PREVIOUSLY PROPOSED ROOF PLAN WITH NEW PROPOSAL OVERLAYS

This drawing addresses the following concerns raised in the email:

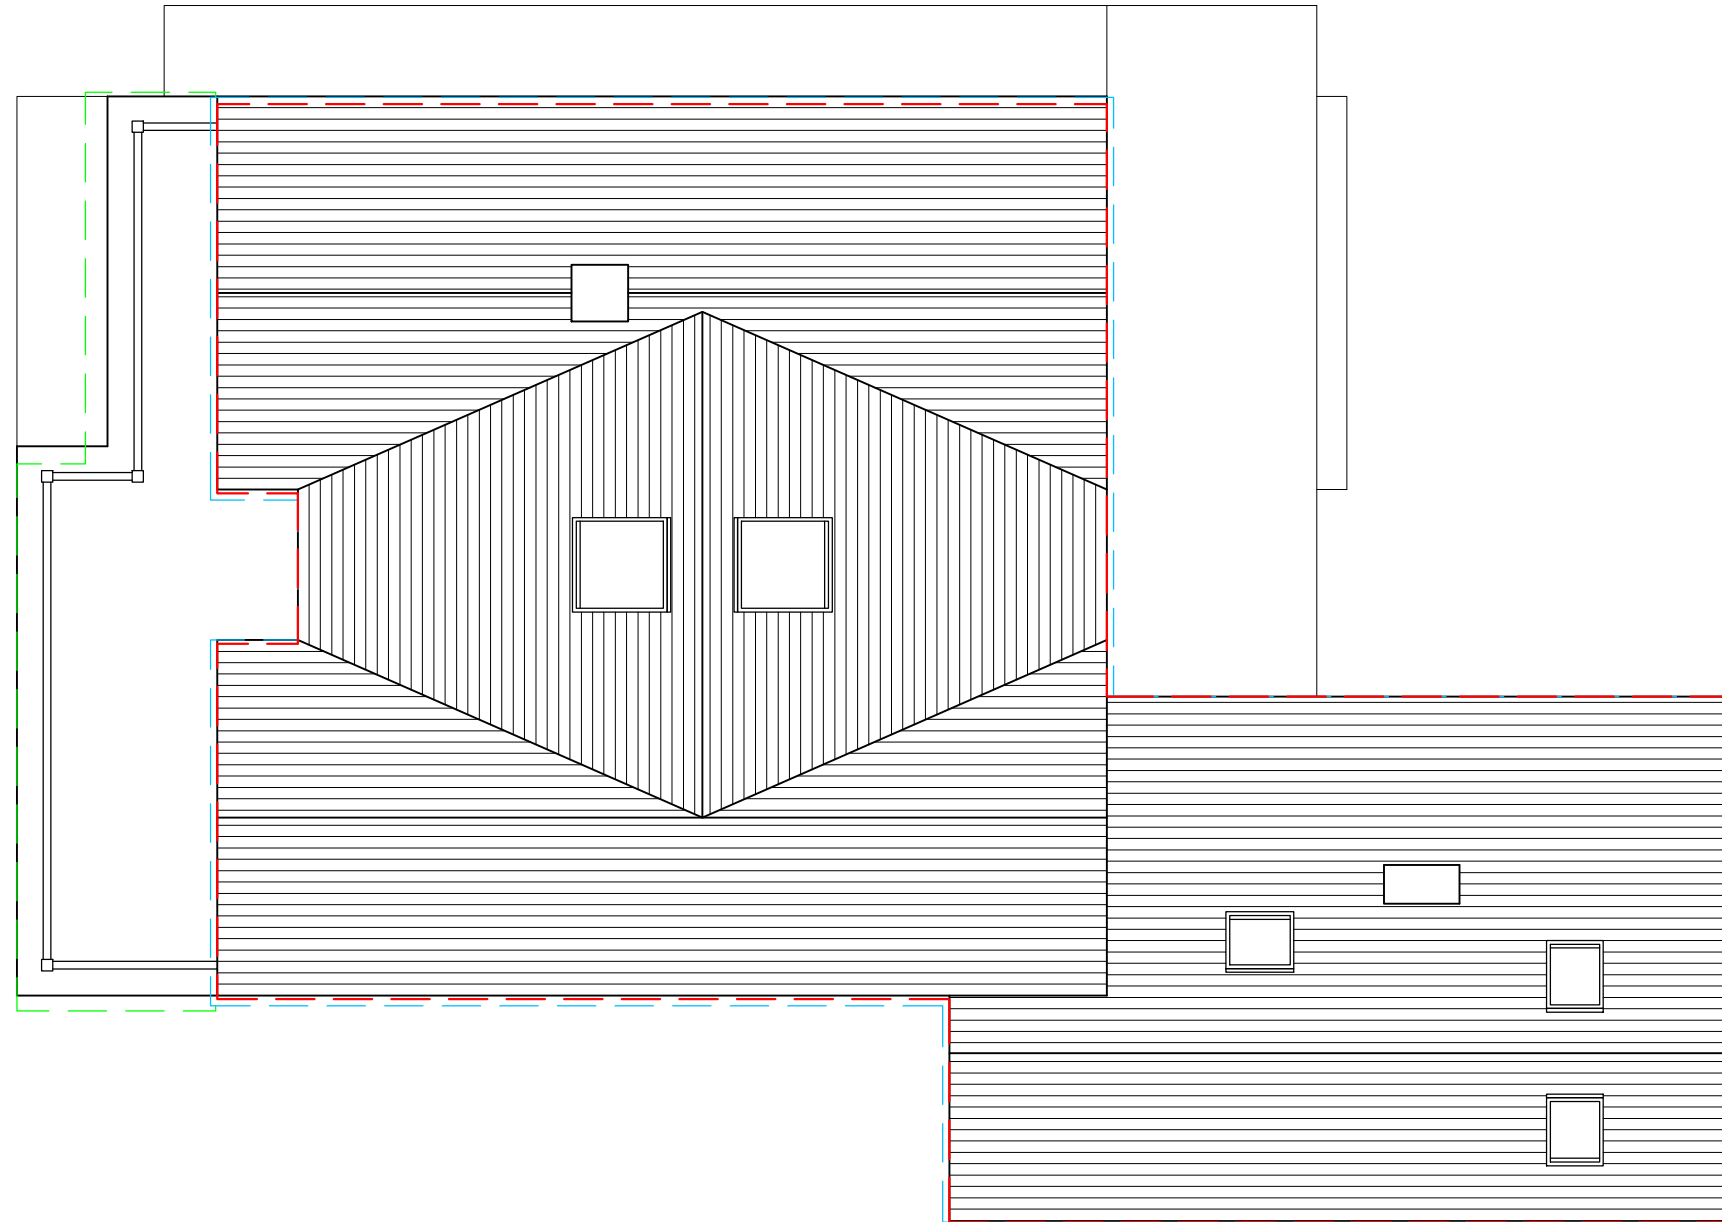
"A plan showing the development previously granted, with the current proposal overlaid, as previously requested. This would enable a full assessment to be made of the current proposal over that which has been granted. My initial assessment is the dwelling is 0.7m longer than that approved, with the width 0.5m wider. That said, I await your overlay plan for a full assessment."

"The balcony should be no further forward than that previously approved, to avoid overlooking and loss of privacy to No. 9. It is claimed this is 0.6m further forward than that approved, which would appear to be the case, with the increased length of the dwelling."
